Notice of Allowability

10/531,542

Proposed Corrections for Figures 3 Through 5 Sheet 2 of 3

FIG. 3

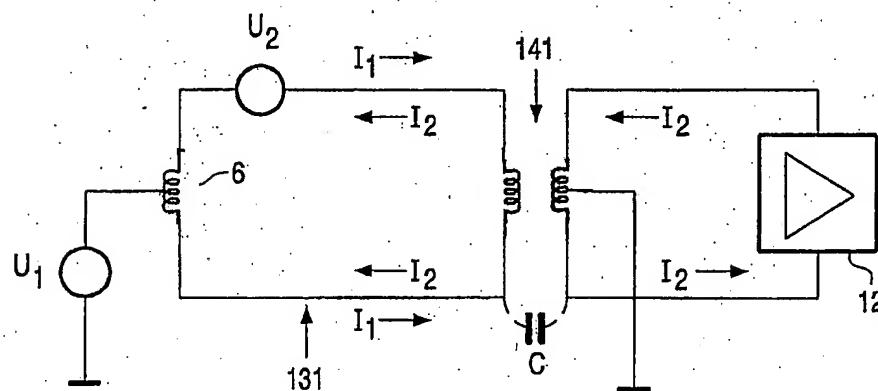
A) **Figures 3, 4, 5, and 8 will be corrected to include the proper schematic symbol for a transformer that is conventional with US practice**, in order to ensure that applicant's figures will properly depict the novelty set forth in applicant's claims, without any ambiguity being caused by use of a non-standard 'transformer' schematic symbol, that may be confused with any, inductive, capacitive, or resistive component, which may not be a transformer. In order to avoid abandonment of the application, applicant must make these above agreed upon drawing changes.

FIG. 6

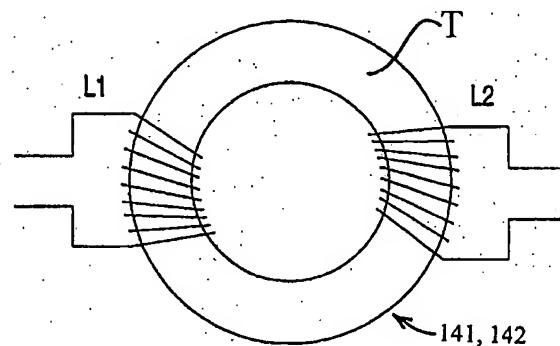
10. The drawing corrections submitted **October 16th 2006** to **figure 6** are approved by the examiner.
